Thoughts on Modified Clause 73 Auto-Negotiation for 1000BASE-T1

IEEE 802.3bp meeting – May 2014
Pat Thaler and Mehmet Tazebay, Broadcom

SUMMARY OF DME PAGE SUGGESTIONS

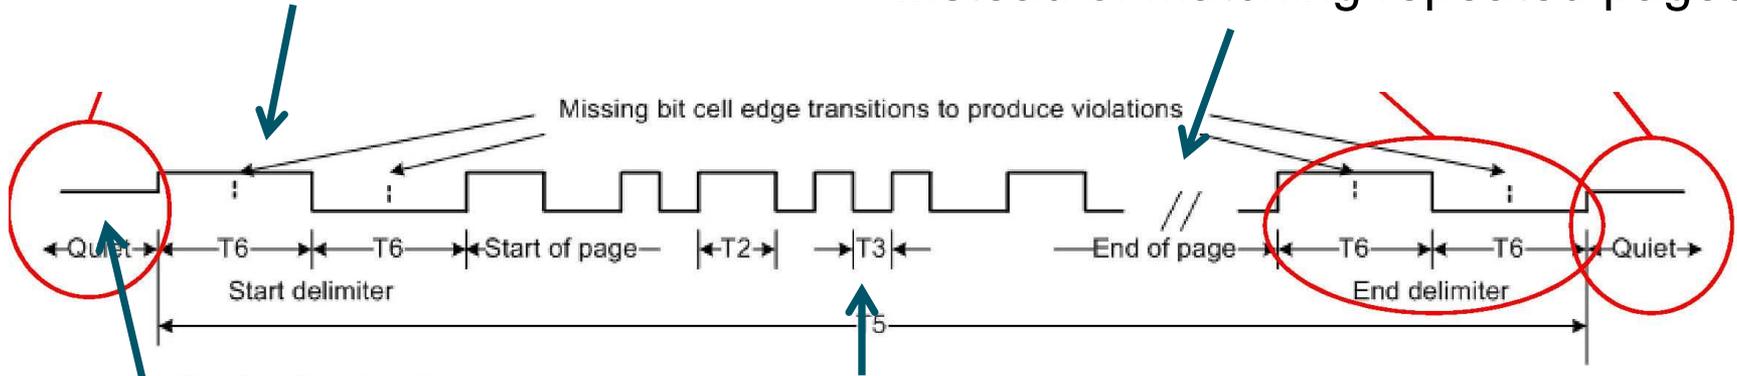
Use $3 * T3$ for Manchester violations

Add 8-bit CRC for validation
Instead of matching repeated pages

Define Silence and add short preamble

Send 2 or 3 copies of page per transmission?

$T3 = 10 \text{ ns nominal}$
